**ADDENDUM NUMBER TWO – JUNE 13, 2019
SPARTANBURG SCHOOL DISTRICT #7
FUTURE MCCrackEN MIDDLE SCHOOL ASBESTOS ABATEMENT
CRE PROJECT NUMBER: PD19-0670-17010**

The following clarifications, amendments, additions, deletions, revisions, and/or modifications are hereby made a part of the Contract Documents, and change the original documents only in the manner and to the extent stated below:

BOILER ROOM ENLARGED DEMOLITION PLAN

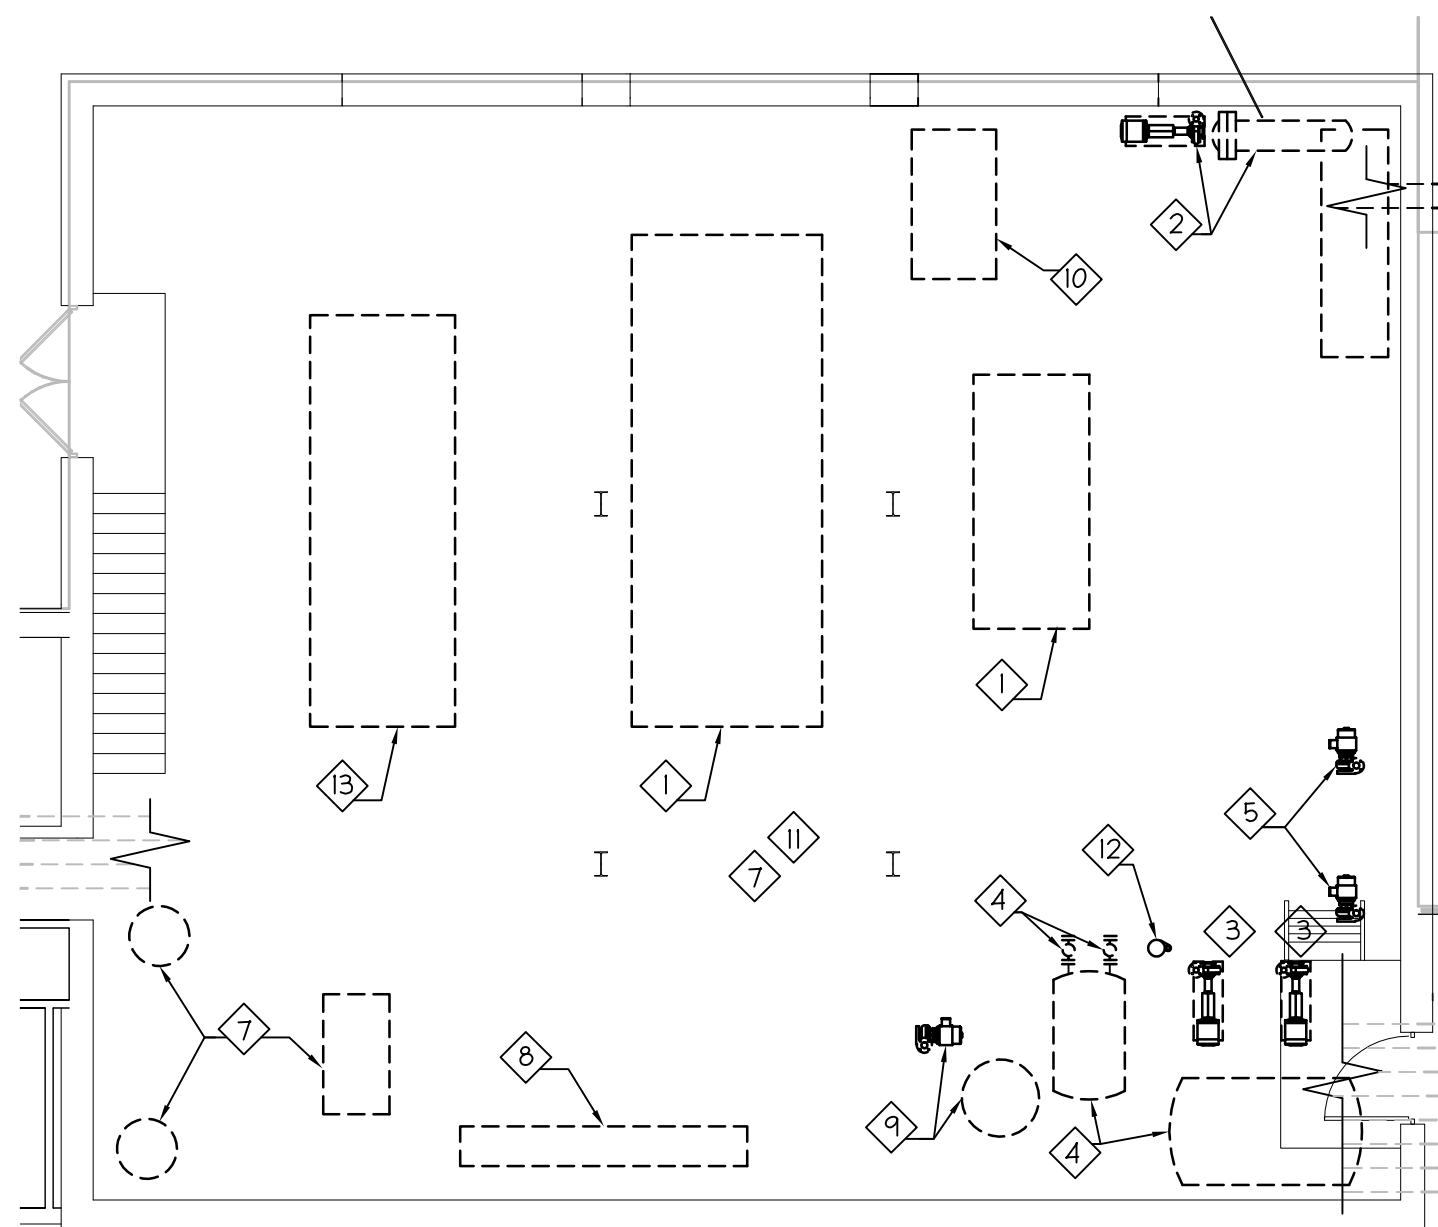
- 2) The question was raised as to whether the Boiler Room is a complete gut, as they would prefer to wrap and cup the piping versus stripping the insulation. Looking at the plans (M102), it appears at least some of the existing piping will be reused.

- 10) Can we glovebag 10' sections, cut and wrap all pipe TSI from the boiler room?

The Boiler Room is a complete gut with regards to steam and condensate piping (refer to demolition plan, drawing M001). A very short run of hot water piping for the "D" wing will remain in service near the location of the existing "D" wing hot water pump, as indicated on drawing M102. Drawings M001 and M102 are included as attachments.

The Boiler Room is a complete gut with regards to steam and condensate piping (refer to demolition plan, drawing M001). A very short run of hot water piping for the "D" wing will remain in service near the location of the existing "D" wing hot water pump, as indicated on drawing M102. Drawings M001 and M102 are included as attachments.
